## Modification instructions for the new control unit, spare part no. 503187

### Models concerned

EDIP607.0E 1. Model with no circuit board  
EDIP607.0E 2. Model with a circuit board  
EDIPEM >approx. 1990 with a circuit board

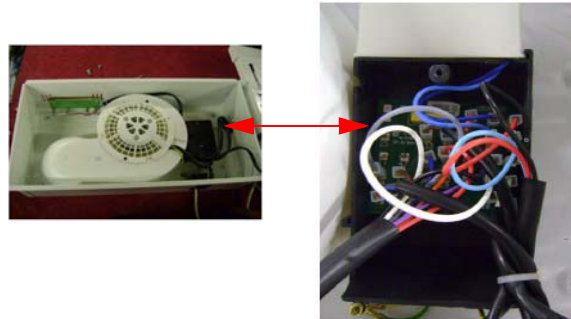
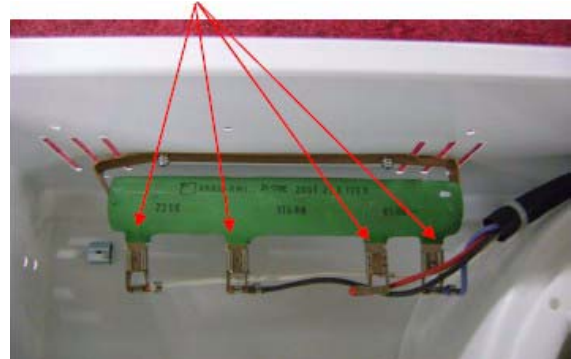
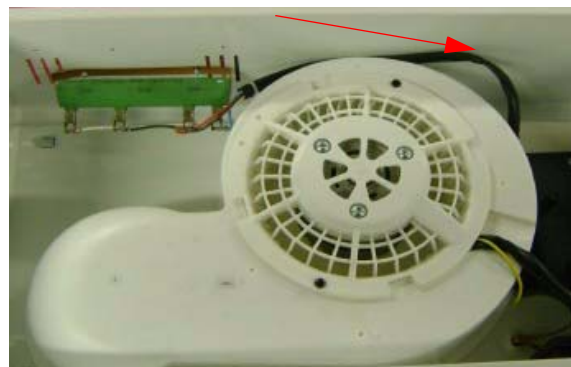
1. Remove all the plug connections from the electronic circuit board.

2. Disconnect the 4 wires from the green resistor.

3. Remove all the green resistor wiring.

### New control unit (spare-part no. 503187)

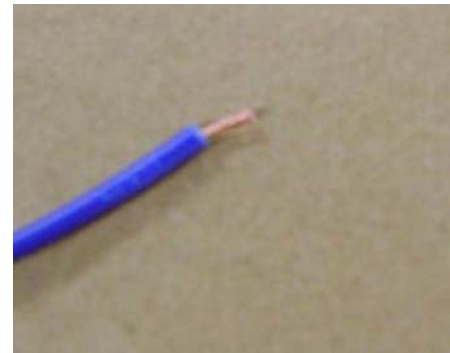
- If you have an appliance **WITHOUT** a circuit board, please carry out steps 4, 5 and 6.
- If you have an appliance **WITH** a circuit board, 4, 5 and 6 will not apply. Commence with step 7.

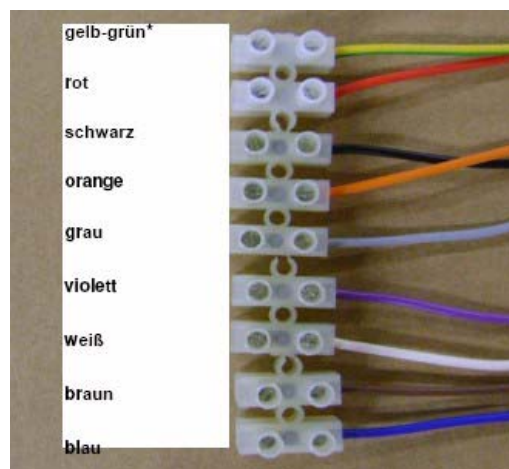
6. Connect all the wires to the new control unit as shown in the adjacent illustration.

from  
the new  
control unit

from the internal  
wiring system

7. Connect the cables to the circuit board as shown on the adjacent chart.

8. Take special care not to mix up the cables for the mains connection (18/19) and the lamp cables (32/33). Check this with the numbers on the lamp cables.
